**TOWN OF MOUNTAIN VILLAGE  
REGULAR DESIGN REVIEW BOARD MEETING  
AGENDA THURSDAY MARCH 31, 2022 10:00 AM  
MOUNTAIN VILLAGE TOWN HALL  
455 MOUNTAIN VILLAGE BLVD, MOUNTAIN VILLAGE, COLORADO  
TO BE HELD HYBRID THROUGH ZOOM:**

AGENDA ITEM 3  
**PLANNING & DEVELOPMENT SERVICE**  
**PLANNING DIVISION**  
455 Mountain Village Blvd.  
Mountain Village, CO 81435  
(970) 728-1392

**Case Summary:** Ken Alexander of Architects Collaborative (Applicant) on behalf of Westport Holding Texas LP, the owner of Lot AR-53R1 is requesting Design Review Board (DRB) approval of an Initial Architectural and Site Review (IASR) Application for a new single-family detached condominium at TBD Adams Way. The existing conditions plan provided by Foley and Associates indicates that Unit AR-53R1 is 6,110 square feet in size. The Village at Adams Ranch is a single-family condominium community and is zoned Multi-Family. The overall square footage of the home is approximately 4,778 gross square feet, with 4,005 livable square feet, and provides two interior parking spaces within the proposed garage and an additional two exterior spaces.

DATE:  
11.18.21  
SHEET  
A1.1  
Unit AR-53R1

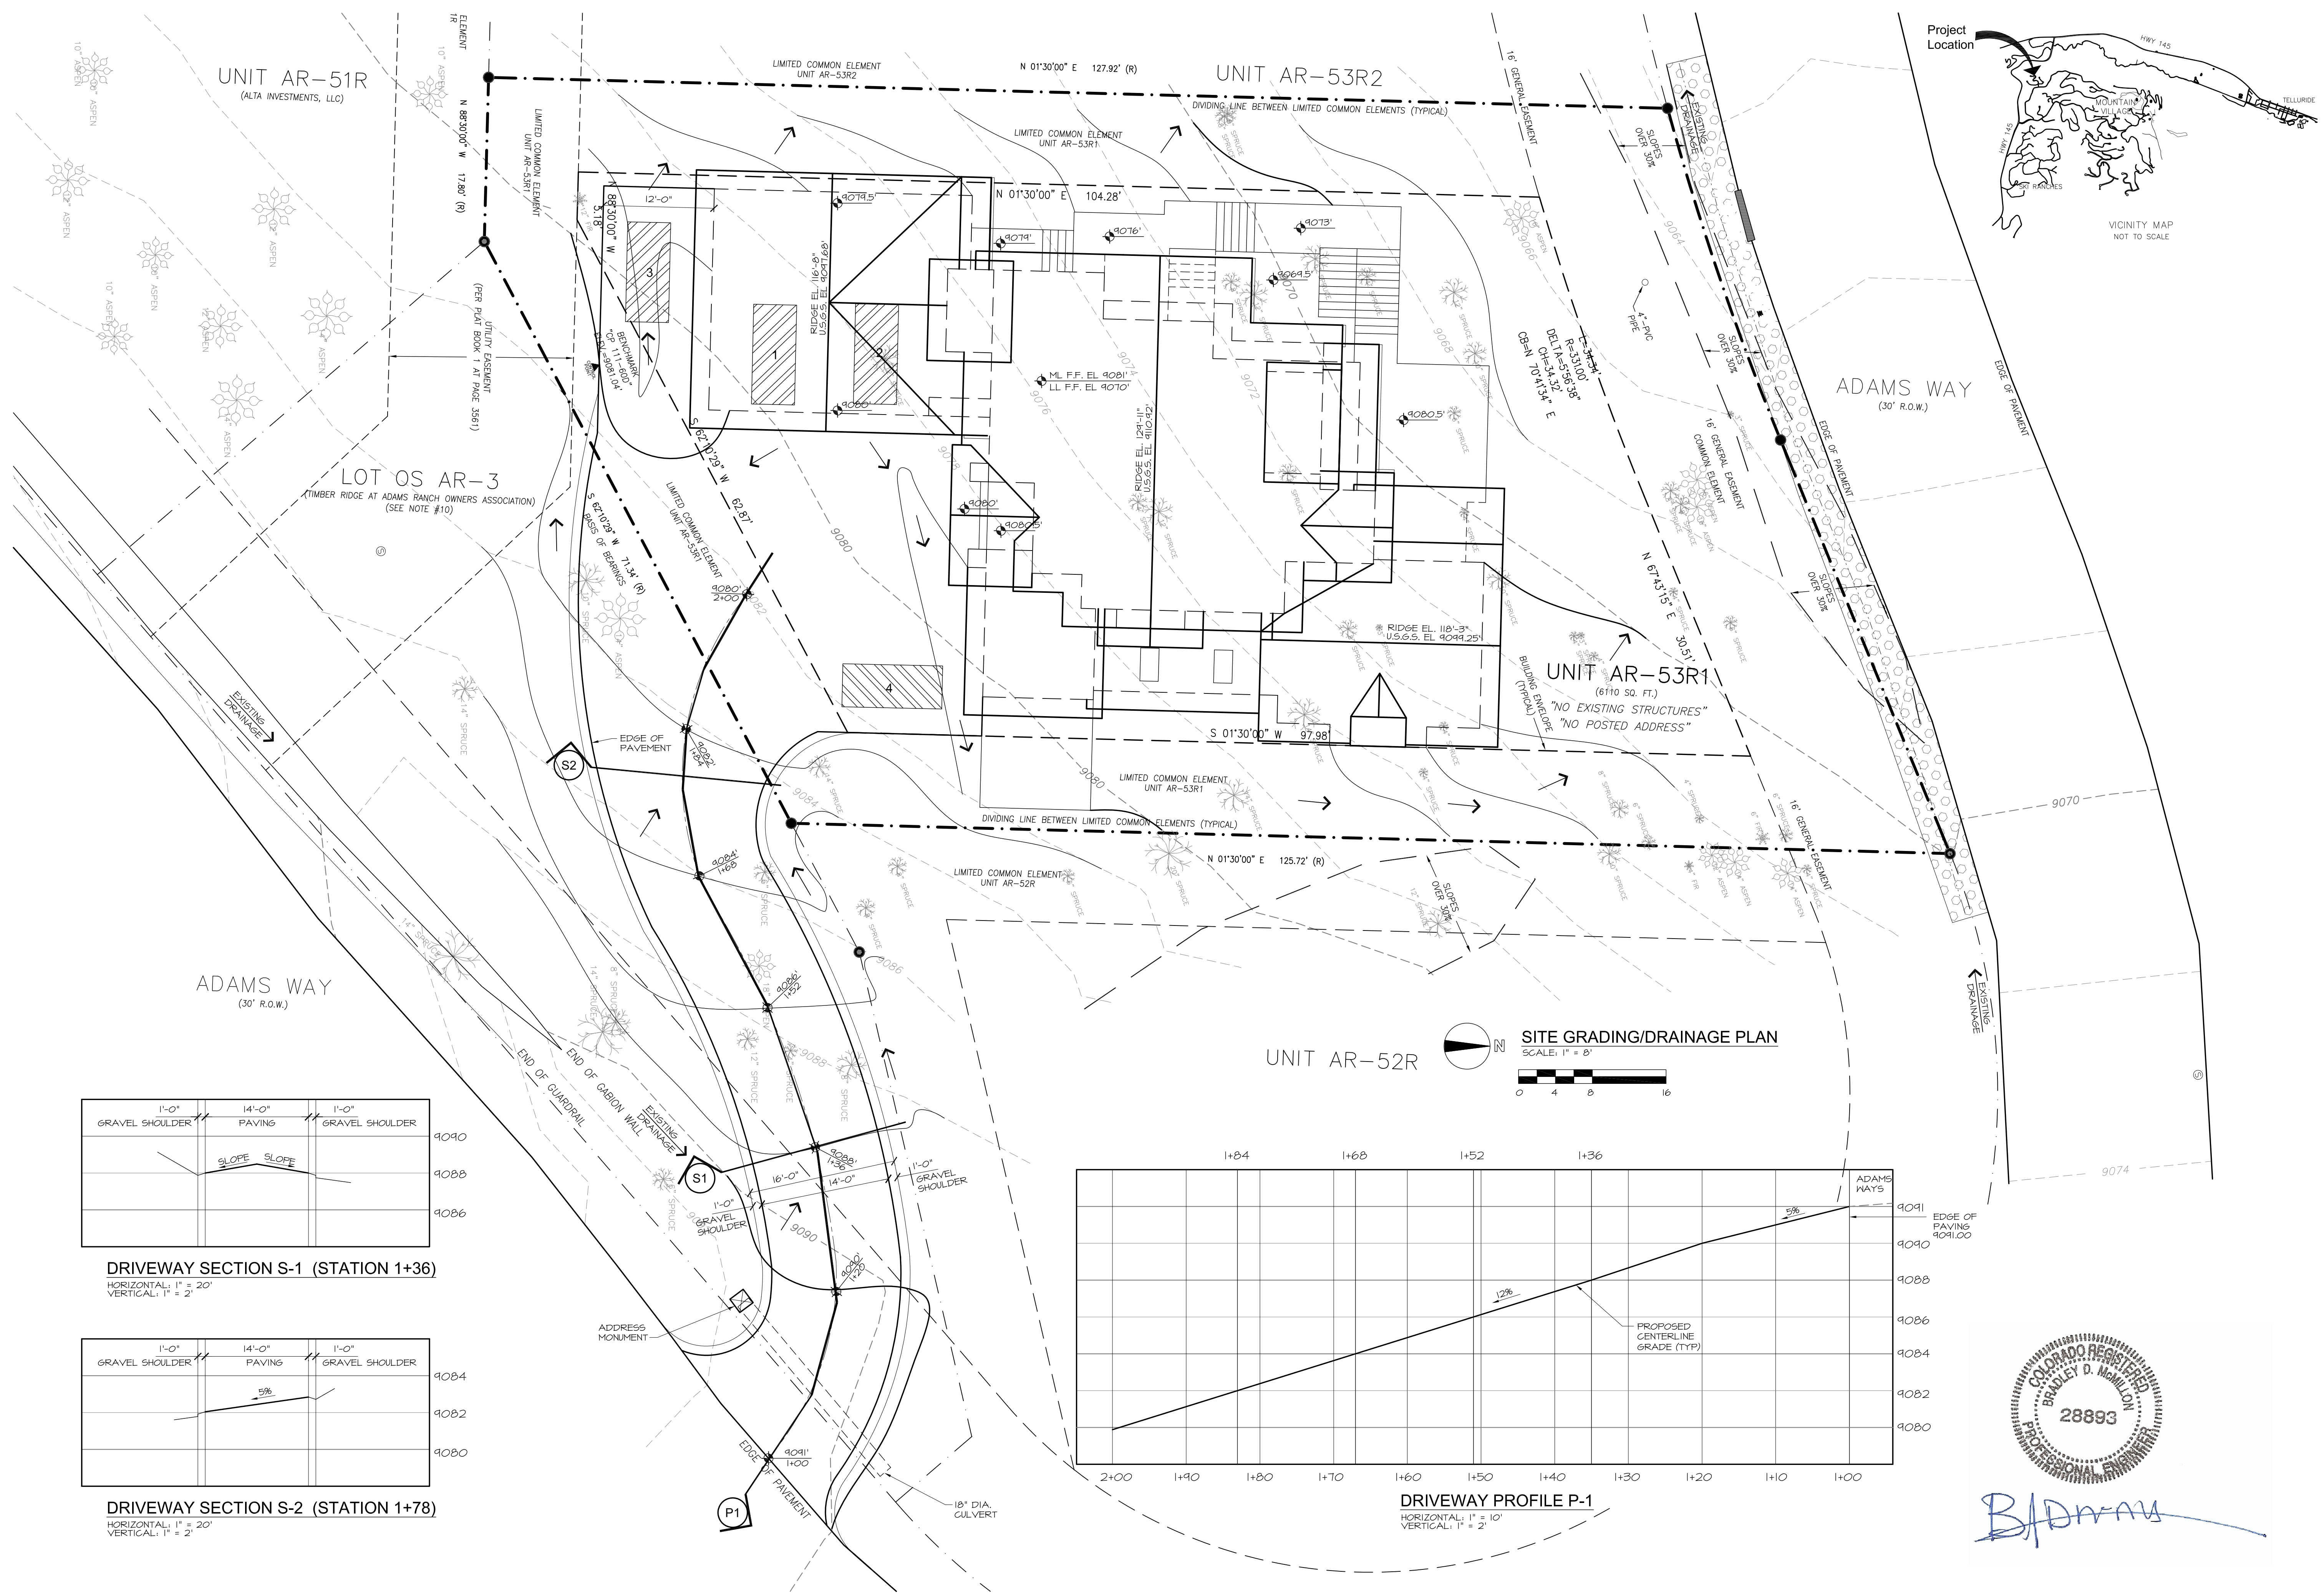
*Staff: The proposed driveway as shown is approximately 14 feet in width with 1-foot shoulders on each side for a total of 16 feet. The driveway as shown has a maximum grade of 12% which is permissible. Driveway sections under 500 feet in length may be allowed a maximum grade up to twelve percent with the approval of the Town in consultation with the Fire Marshal, providing all structures are equipped with a fire sprinkler system. The current proposed access design does not show any retaining walls associated with the driveway but due to the grades, staff would like to verify this prior to final review. Otherwise, the applicant is meeting the requirements of the CDC for driveway design.*

**SITE GRADING/DRAINAGE PLAN**  
SCALE: 1" = 8'

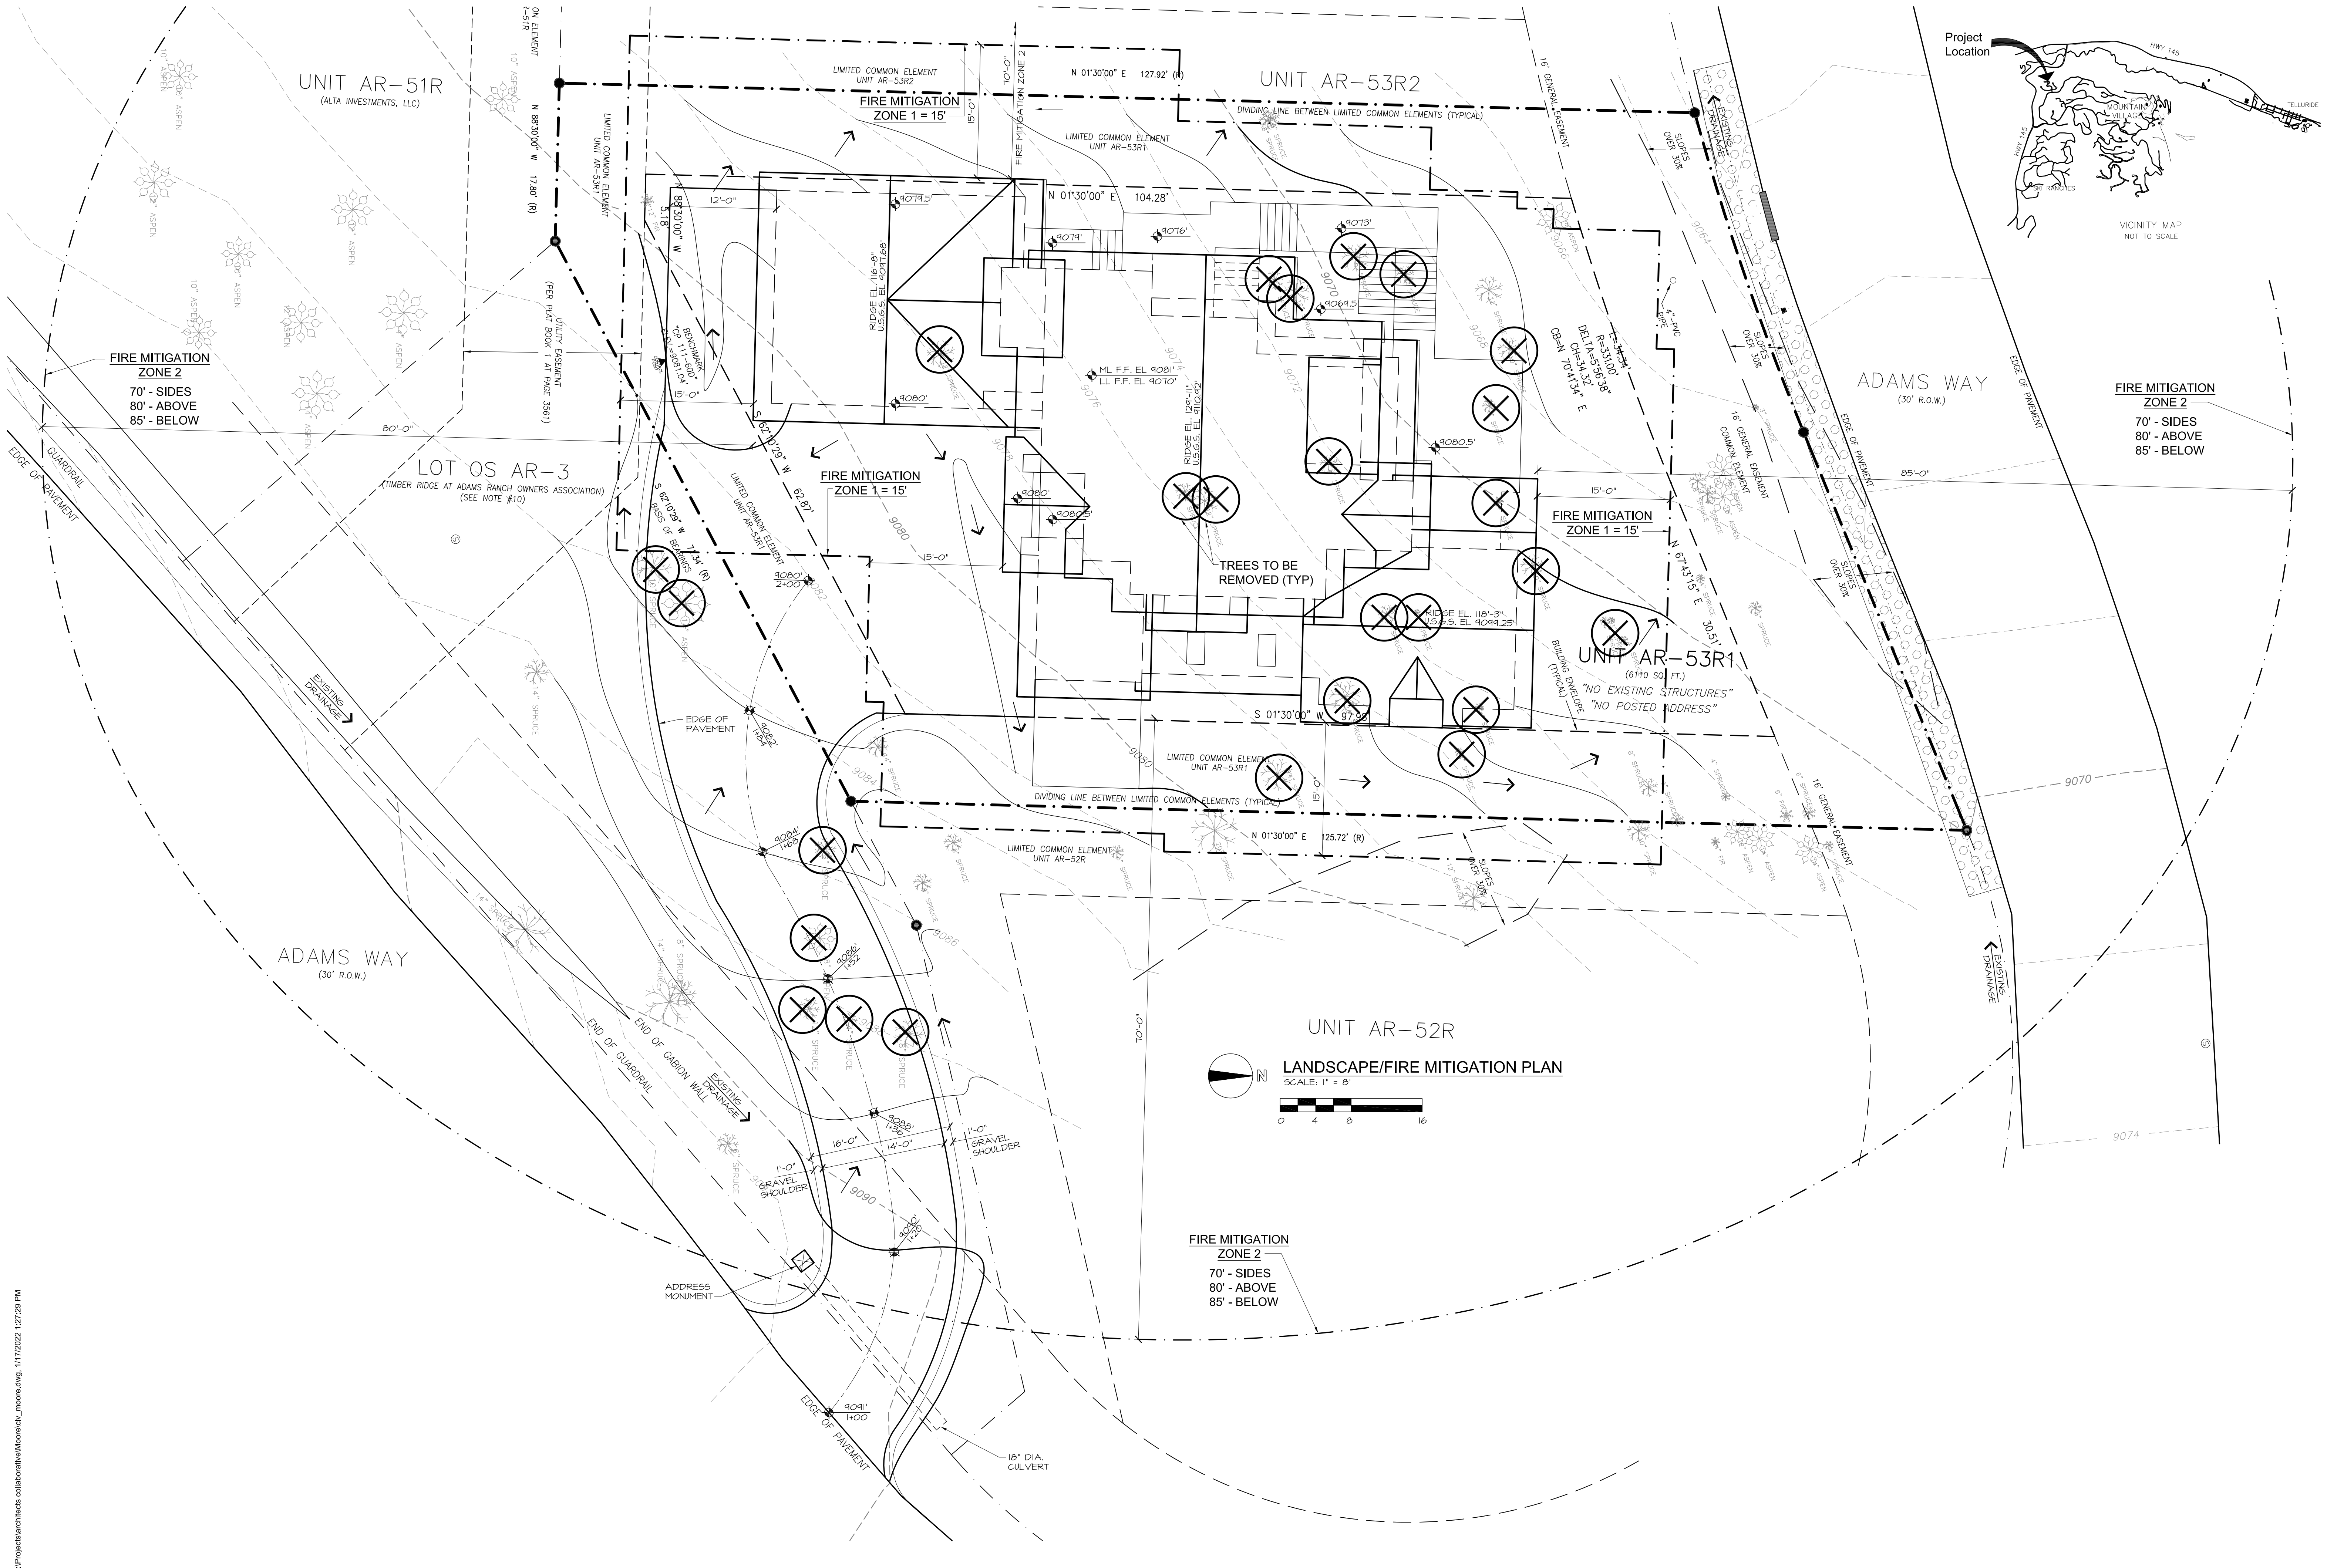
*Staff: The grading plan shows positive drainage away from the home but there have been comments expressed by neighboring homes related to off-site impacts of the drainage – especially to the west of the home. It appears based on the proposed drainage plan, that additional drainage facilities could be included in the western LCE that could direct water away from adjacent homes and towards Adams Way to the North. This minor change could alleviate some concerns related to drainage impacts.*

Reviewing the Site Drainage/Grading Plan of AR-53R1, there are only arrows pointing westward, indicating that drainage from AR-53R1 will be directed into our property which is approximately

16.5 feet away. (The AR-53R1 home is currently proposed to be built to the western property line.) We are very concerned about mud/rain/snow runoff issues inherent in such a plan. We respectfully request that these modifications to the existing natural drainage patterns be specifically approved by a Town of Mountain Village Civil Engineer and/or any other governing agency having jurisdiction on this issue.
